Our Reference: VA101-1/18-A.01
Continuity Nbr.: VA07-01853

Re: Mount Polley Stage 6 TSF Design

This letter is in response to comments by Mr. Chris Carr who has requested the following information before proceeding with the permit conditions for the Stage 6 embankment raise for the Tailings Storage Facility at Mount Polley Mine. Mr. Carr's comments and responses from Knight Piésold are as follows:

MOUNT POLLEY MINING CORPORATION	
MOUNT POLLEY MINE	
TAILINGS STORAGE FACILITY MAIN EMBANKMENT STABILITY SECTION	
<i>Knight Piésold</i> CONSULTING	PROJECT / ASSIGNMENT NO. VA 101-1/18
	REF NO. VA07-01853
FIGURE 1	
	REV. 0

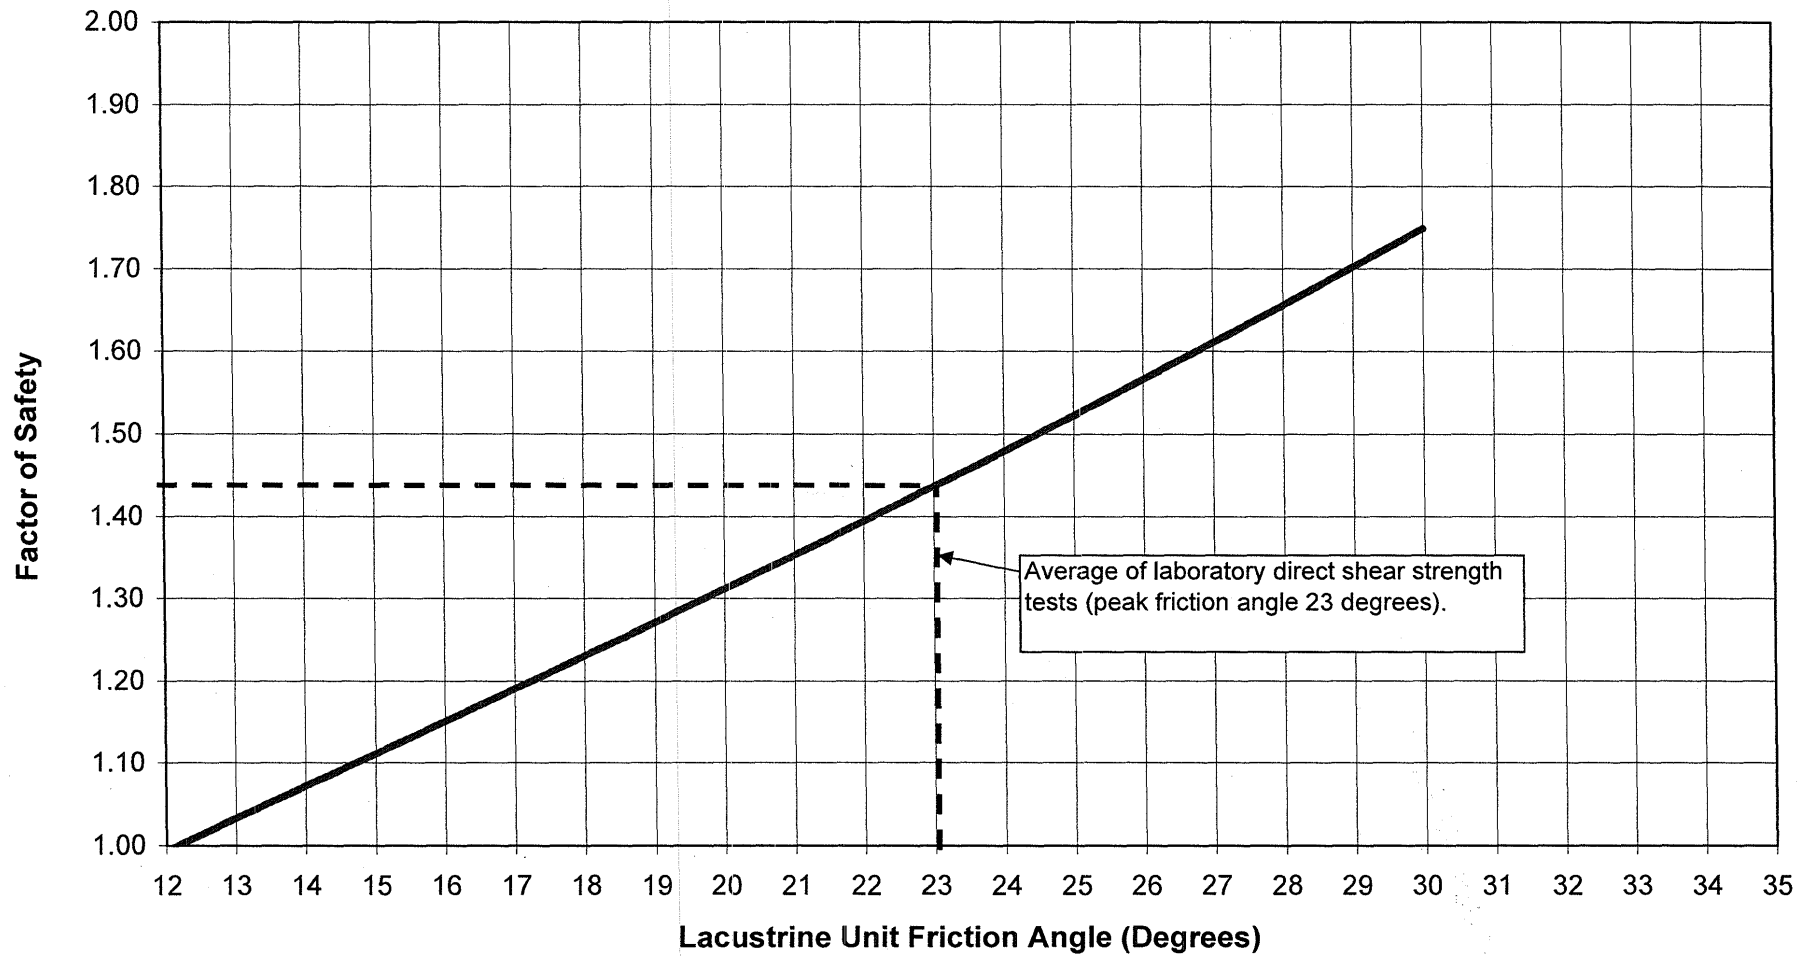
Provide cross-sections showing stability analyses for dam raise to elevation 958 m.

The cross-section used for the stability analysis for the Main Embankment is shown on Figure 1. The cross-section includes the following:

- The embankment crest was modelled with an embankment elevation of 958 m,
- The downstream buttress was modelled at an elevation of 925 m. The current elevation of the downstream buttress is 917 m. The Stage 6 construction program involves raising the elevation of the buttress to elevation 925 m to ensure that the required Factor of Safety is achieved for the Stage 6 embankment configuration.

- The lacustrine unit at the Main Embankment was modelled with a thickness of 12 m. A study comparing the drained residual strength to the clay content, liquid limit, and effective normal stress was completed by Stark and Eid (1995). The results of the study indicate that the drained residual strength of a material with a clay content ranging from 25 to 50%, with a liquid of 40%, and an effective normal stress of 700 kPa is in the order of 24 degrees. A conservative friction angle of 24 degrees was applied for the lacustrine unit. Subsequent direct shear tests conducted by Knight Piésold also indicate that the peak friction angle of the lacustrine unit is in the range of 21 to 25 degrees, (average of 23 degrees). The average residual friction angle at 20% strain was 22 degrees.

- The stability analysis was completed with the elevated pore pressures in the lacustrine unit (approximately 2.5m above ground) as the piezometers installed in the lacustrine material indicate slight artesian conditions within this material.

The results of the stability analyses indicate that the factor of safety for the Stage 6 TSF Main Embankment for static conditions was approximately 1.48 for a lacustrine friction angle of 24 degrees. A sensitivity stability analysis was also completed using different friction angles for the lacustrine unit. The results of the sensitivity stability analysis are shown on Figure 2. The factor of safety was approximately 1.44 for a friction angle of 23 degrees, the average friction angle from the direct shear tests on the lacustrine unit. The factor of safety for the lower end direct shear test friction angle of 21 degrees was approximately 1.35. The sensitivity analysis also demonstrates that the embankment would remain stable with a factor of safety greater than 1.1 for an extreme lower bound residual friction angle of 15 degrees for the lacustrine unit.

MOUNT POLLEY MINING CORPORATION		
MOUNT POLLEY MINE		
TAILINGS STORAGE FACILITY INCLINOMETER SI01-01 DISPLACEMENT VS. DEPTH		
<i>Knight Piésold</i> CONSULTING	PROJECT / ASSIGNMENT NO. VA101-1/18	REF NO. VA07-01853
	FIGURE 3	
		REV. 0

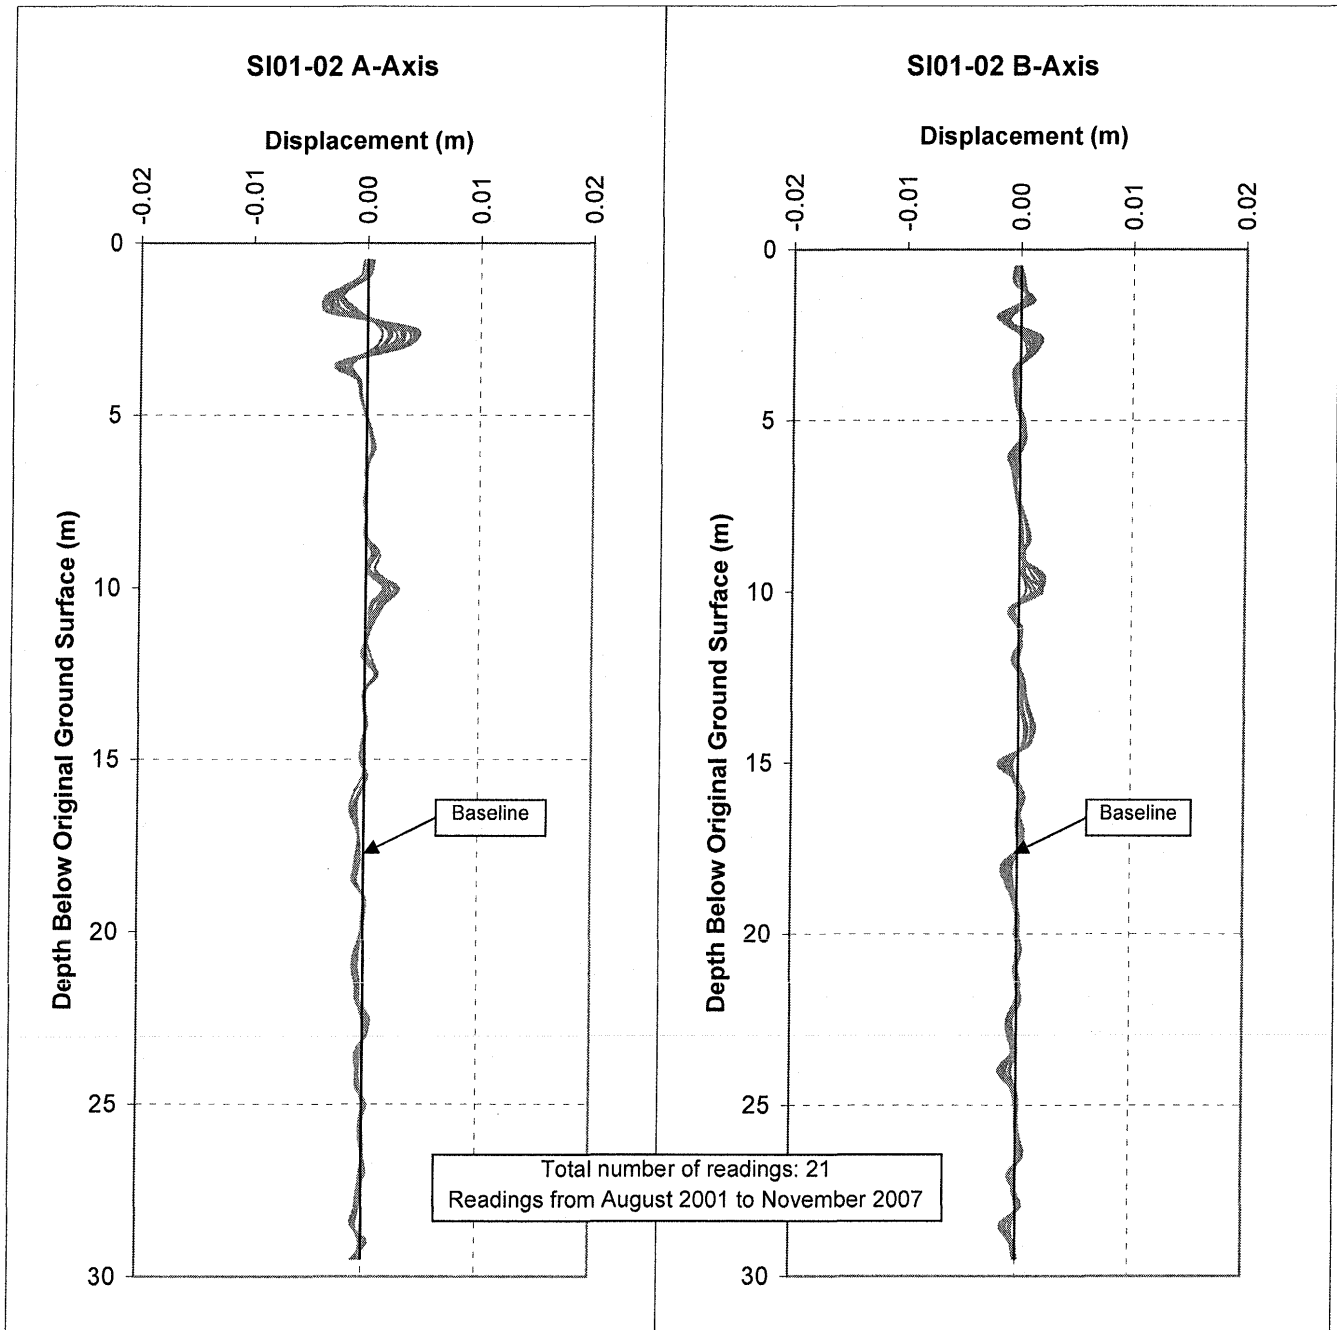
Provide slope inclinometer depth vs. cumulative displacement plots showing cumulative displacement from date of installation.

Three new slope inclinometers were installed downstream of the toe of the Main Embankment during the Stage 4 construction program. One of the inclinometers installed in 2001 (SI01-01) was damaged during the placement of the shell zone material and is no longer functioning. The last reading for SI01-01 was March 2006. There are four functioning inclinometers installed at the Main Embankment.

The results of the inclinometer readings indicate that there have not been any significant deviations measured in the inclinometers since their installation. There were no measurable deformations recorded

in the inclinometers during or after the Stage 5 construction program. The results of the readings for inclinometers are shown on Figures 3 to 7.
